WEEE TREATMENT FACILITY AT WEEE RECYCLE 4U Co. LTD, HAL FAR

APPLICATION FOR IPPC PERMIT

VOLUME 5: RESPONSE TO FEEDBACK ON IPPC APPLICATION

Version 4: September 2020

Approved Ground Floor
 Scale 1:200 PA 5335/18

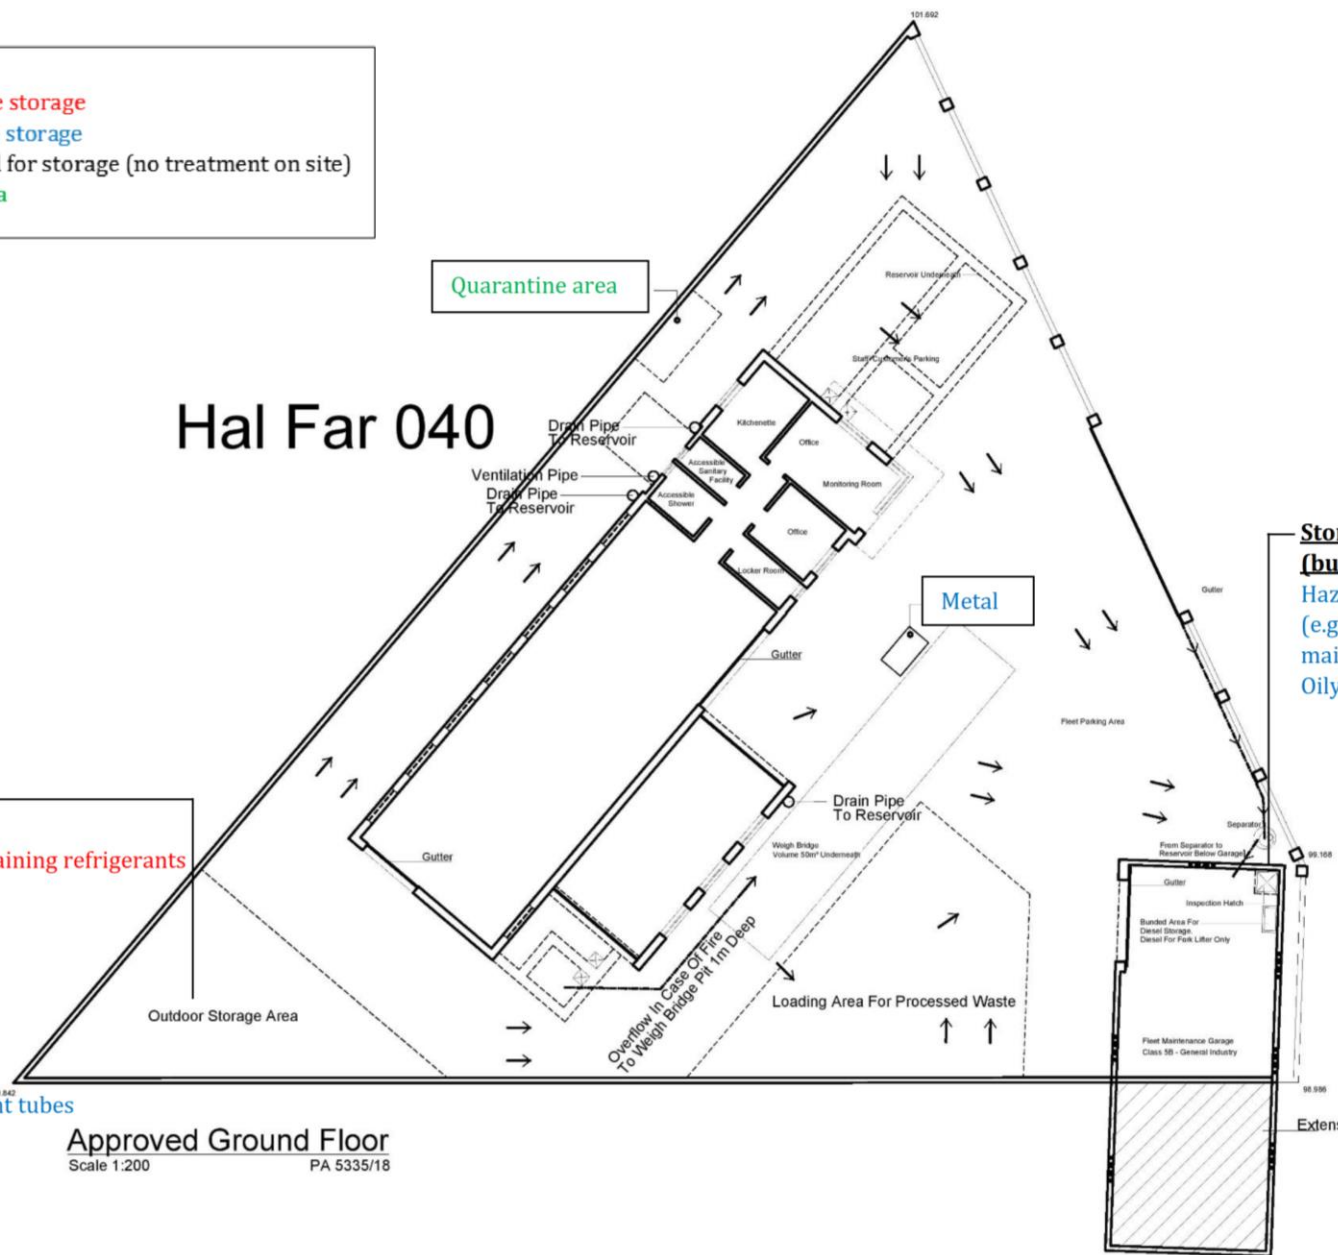
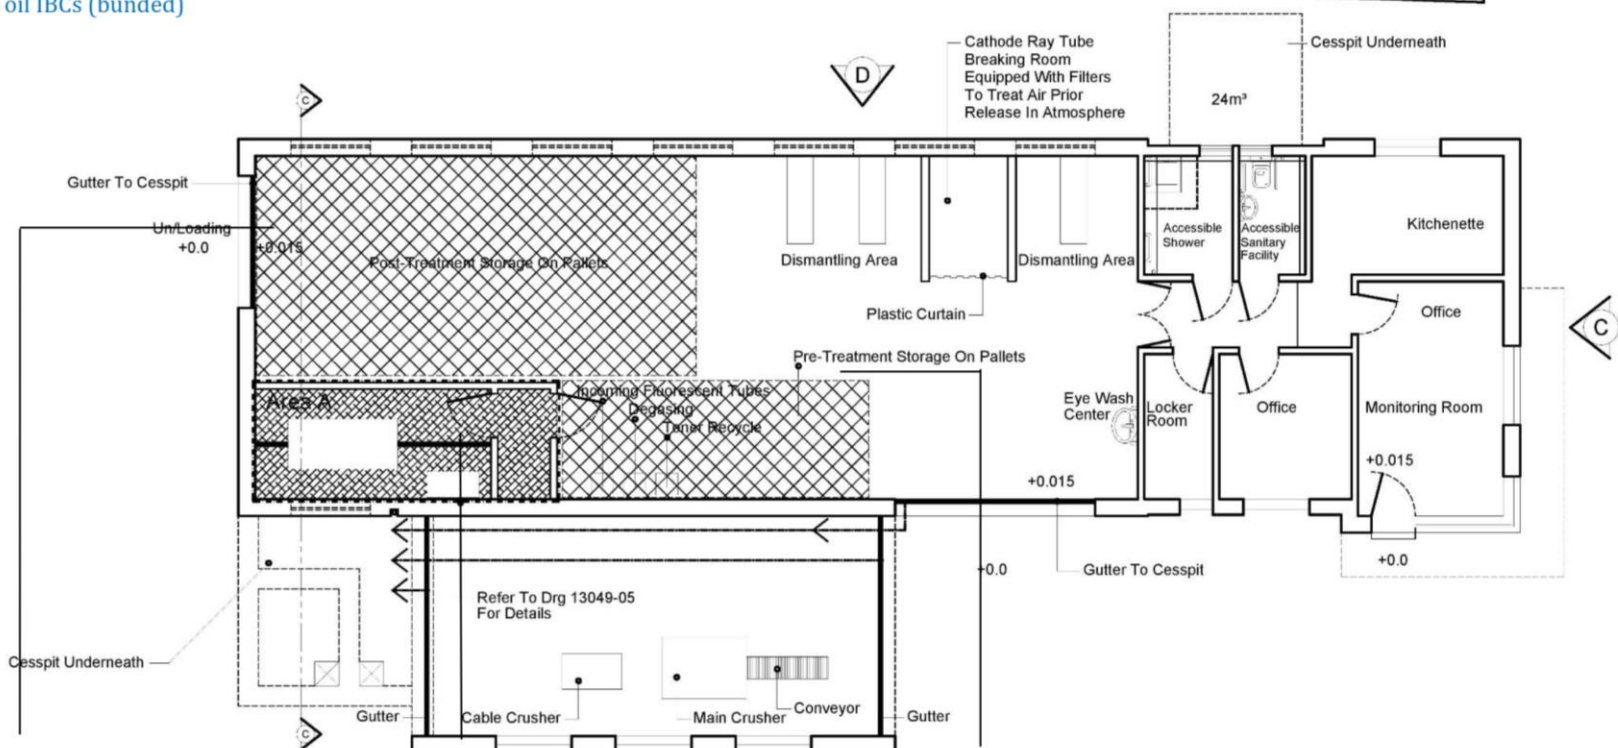
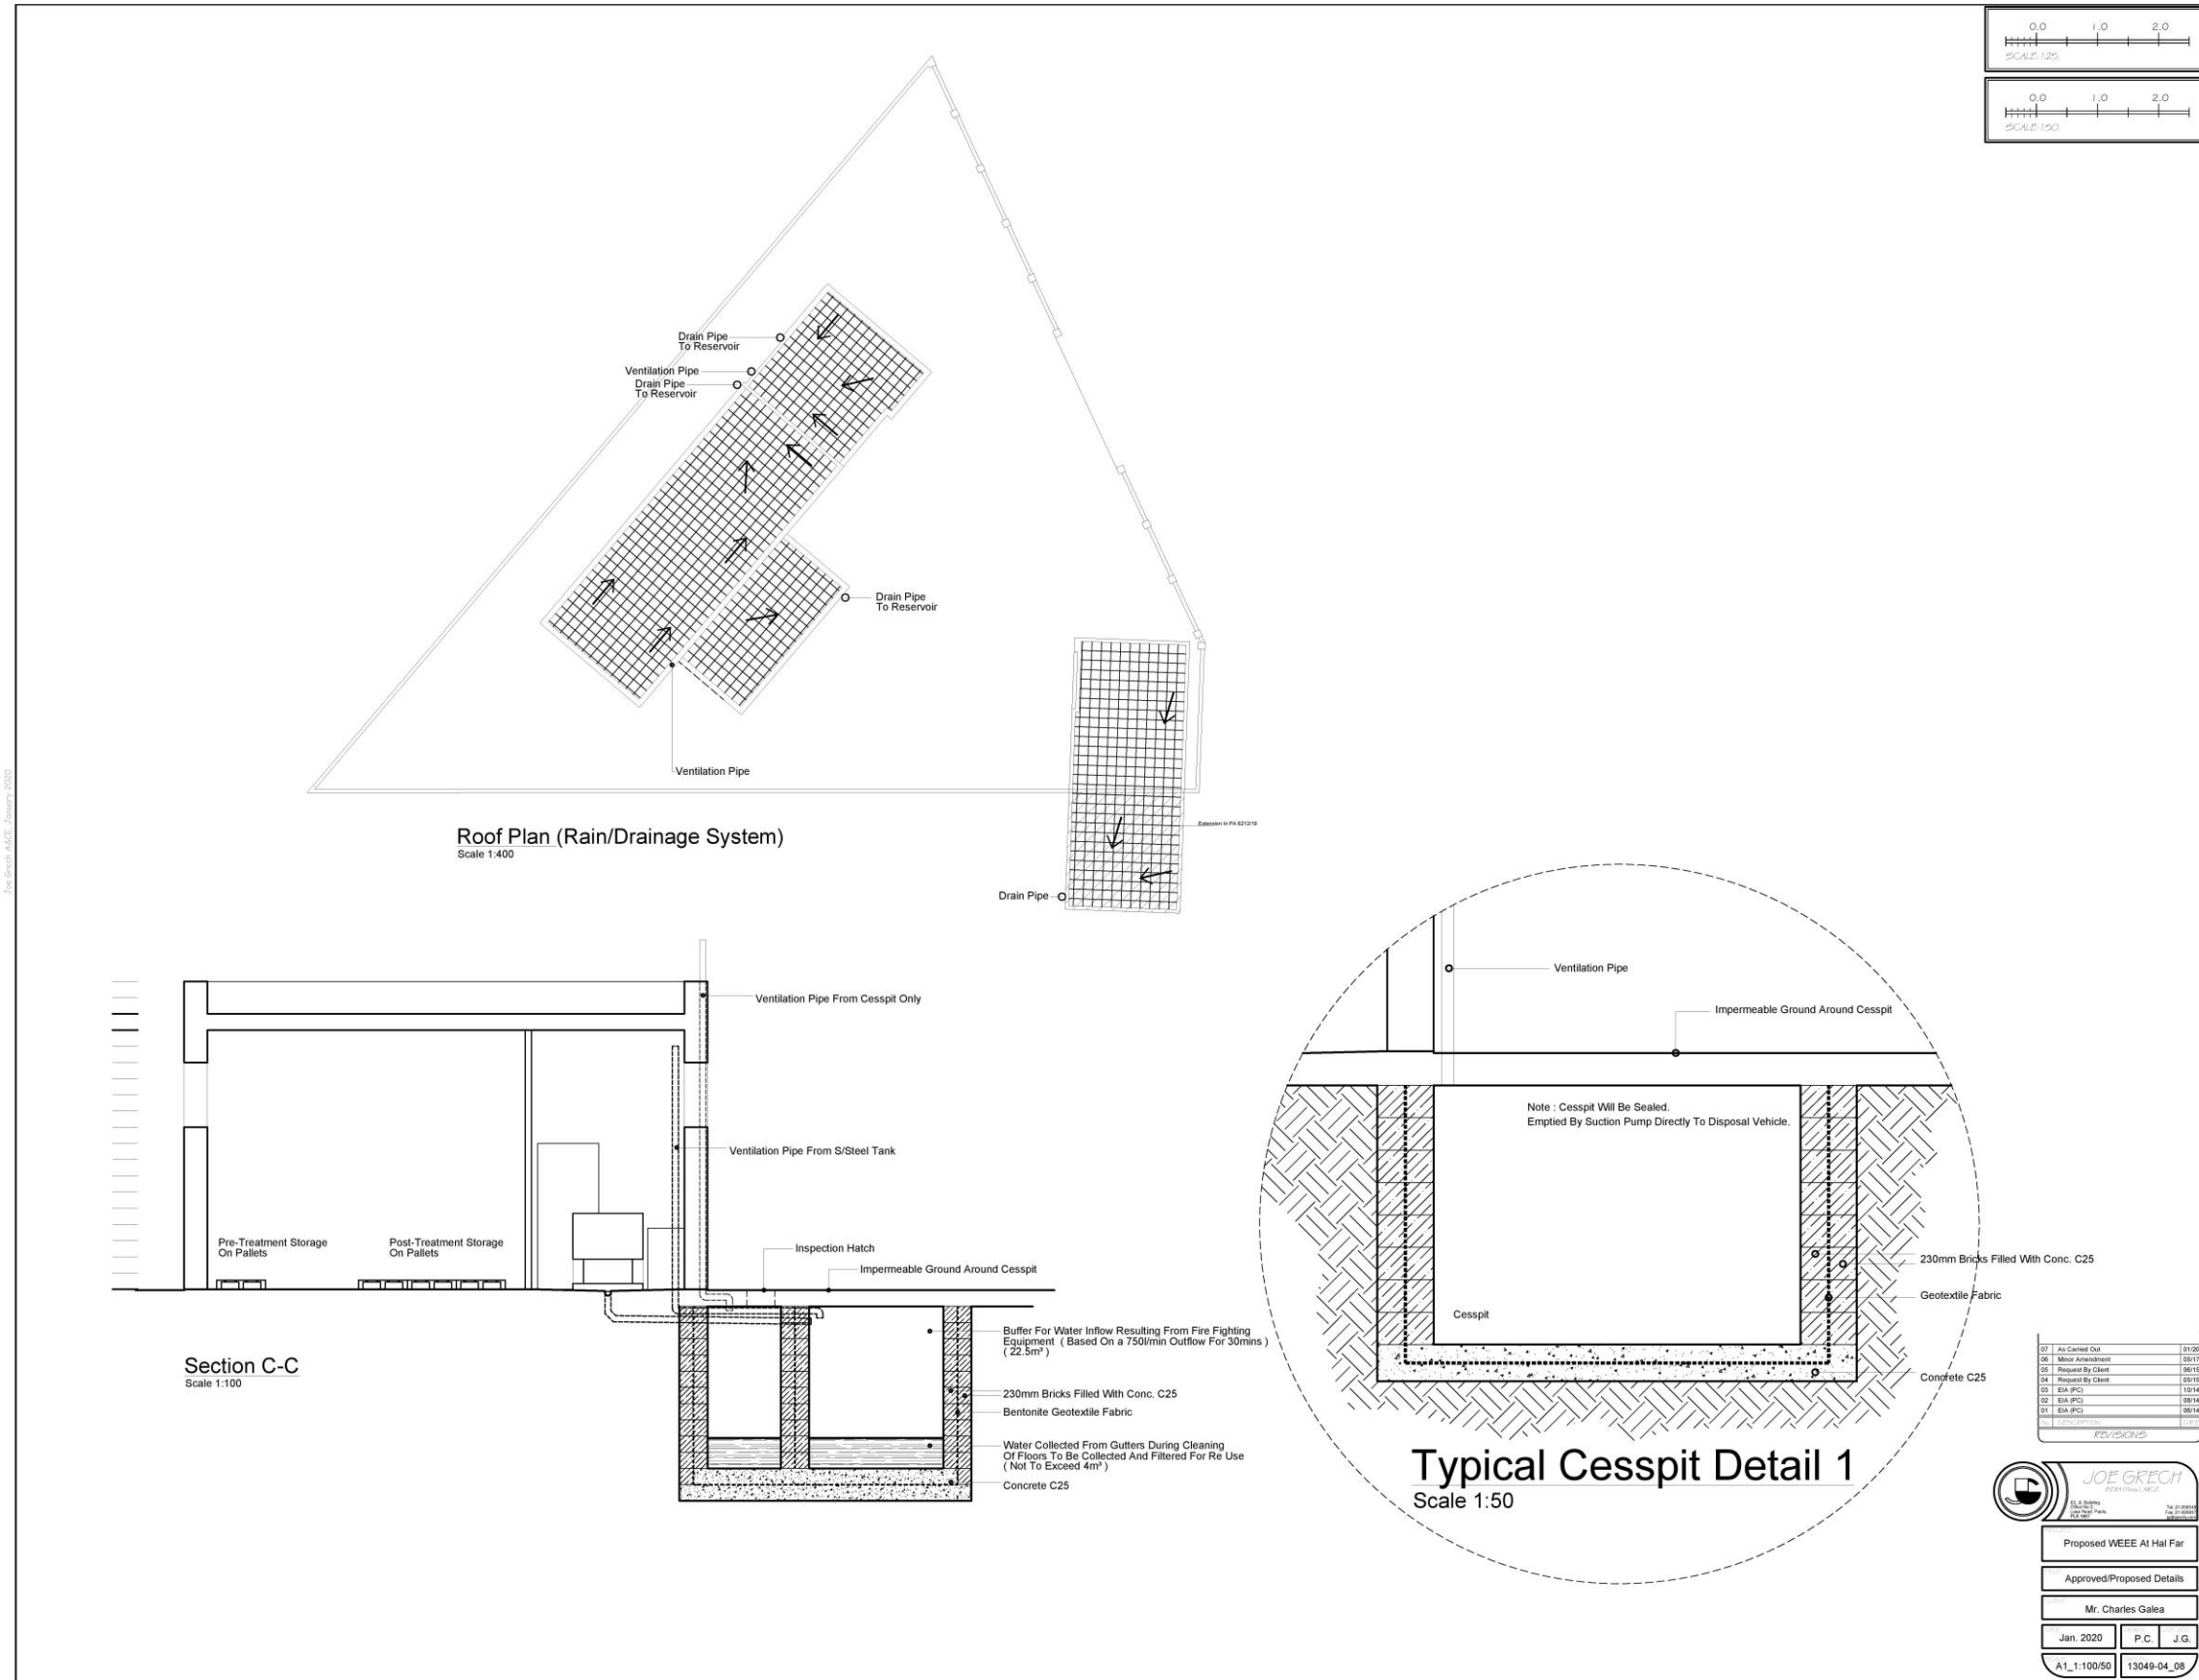
7.				The regular temporary storage of the Industrial Vacuum Cleaners being proposed are to be clearly indicated on site layout plan to be submitted to ERA Such vaccum cleaners are also to be certified by a warranted engineer Similarly all Spill Kits and HazWaste Bins (disosable overalls and used spill kits) are to be similarly iindicated in this layout plan.	Applicant is to provide the requested layout plan.	Please refer to Appendix 1 .

Drawing : NSBP003,004 & 006 Sales Drawing

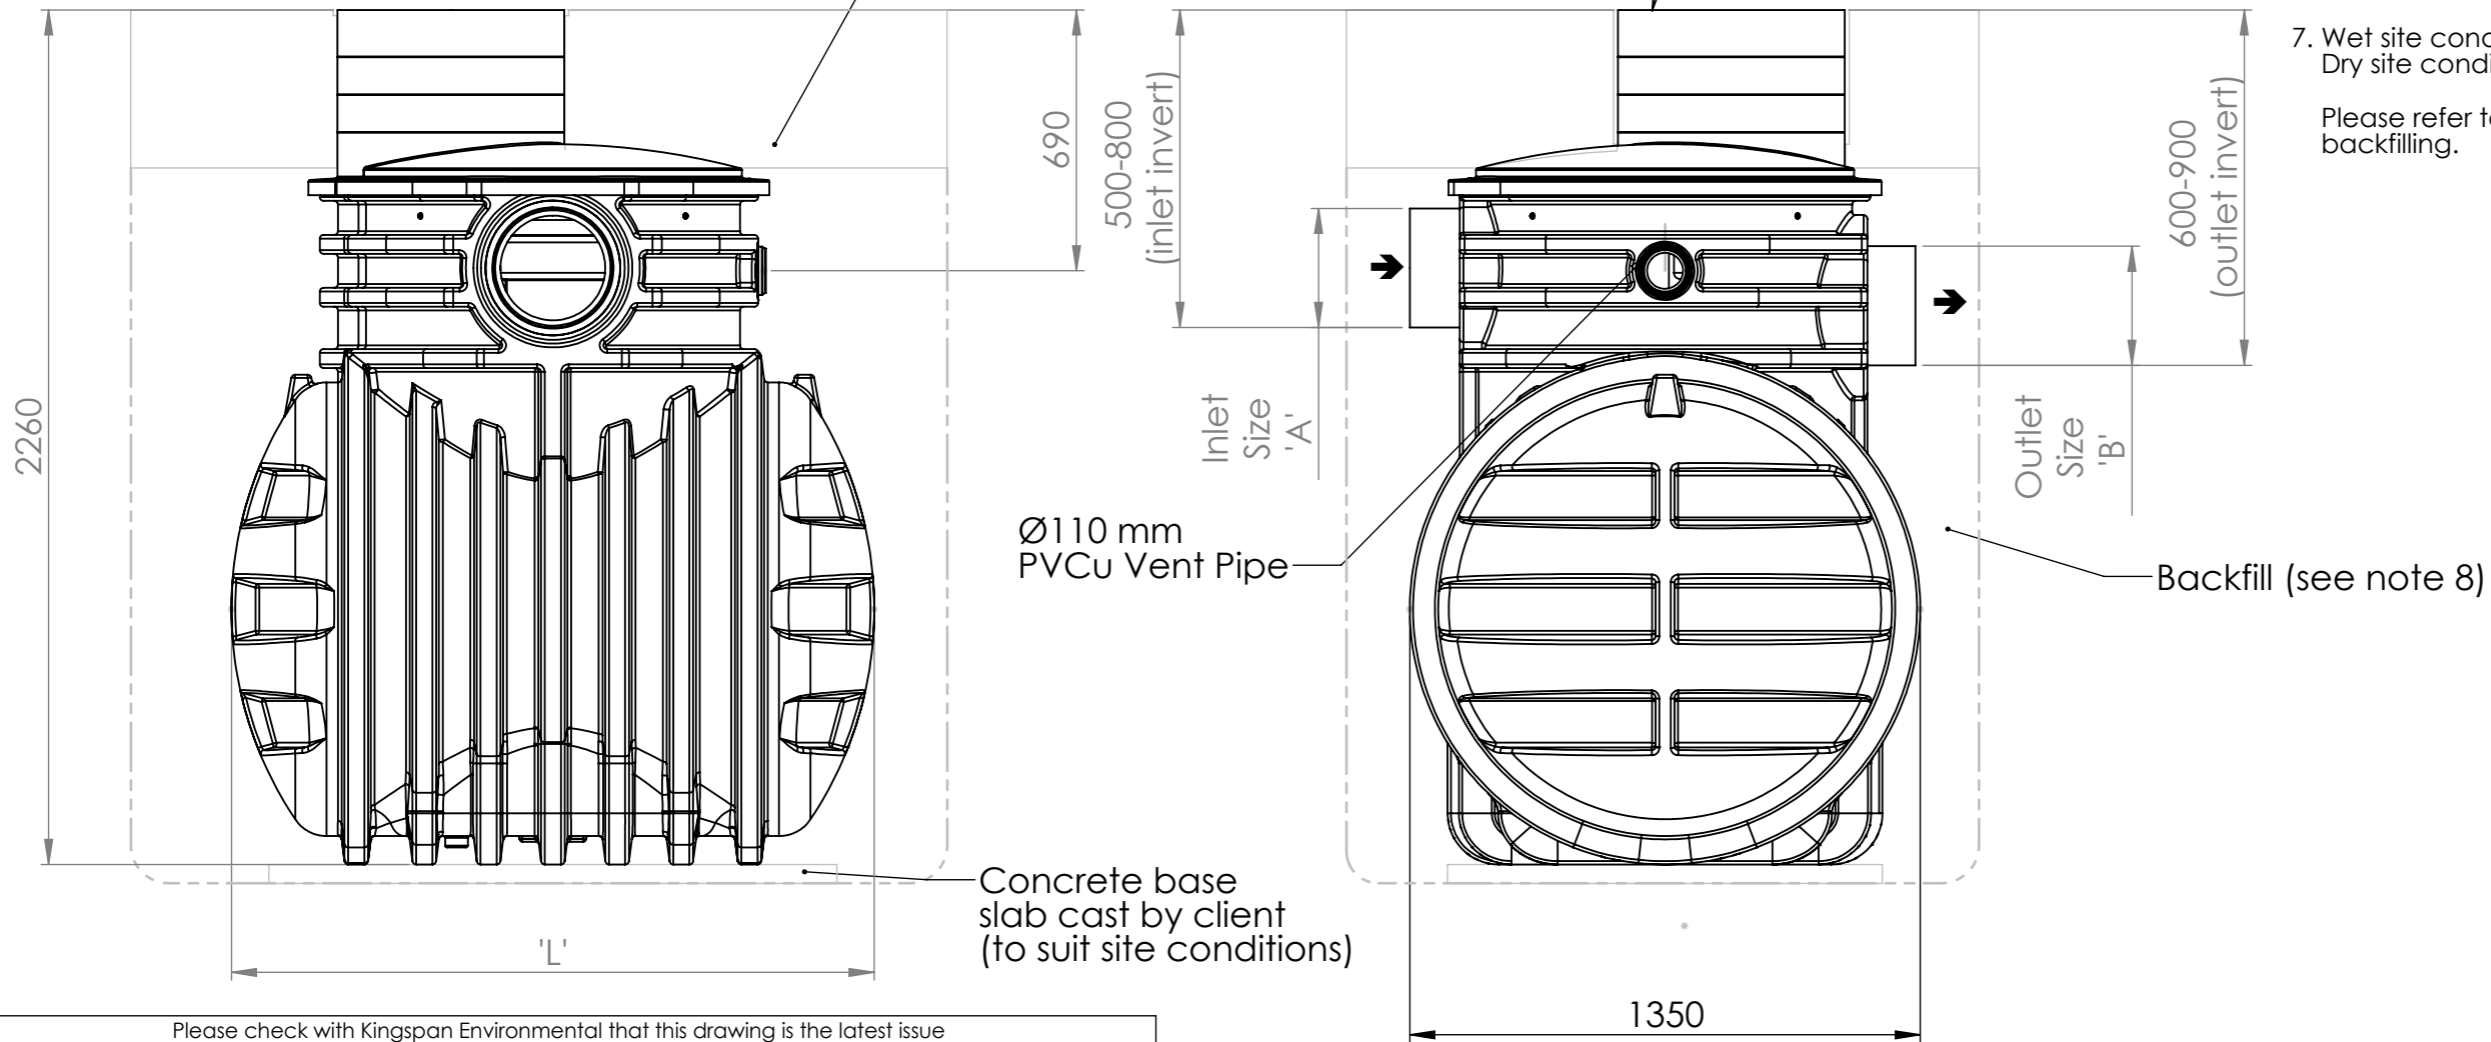
B2.2.2	✓	No attachment provided	1. With reference to paragraph 3.34. in section B2.2.2 (page 31) kindly provide specification of the oil-water interceptor including details of the volume of wastewater which can be treated. Kindly clarify whether	1. The requested specifications, including drawings, are provided in Appendix 2 . The model number that will be installed will be the NSBP003, which has a flow rate of 3 L/s and an oil storage capacity	Noted.
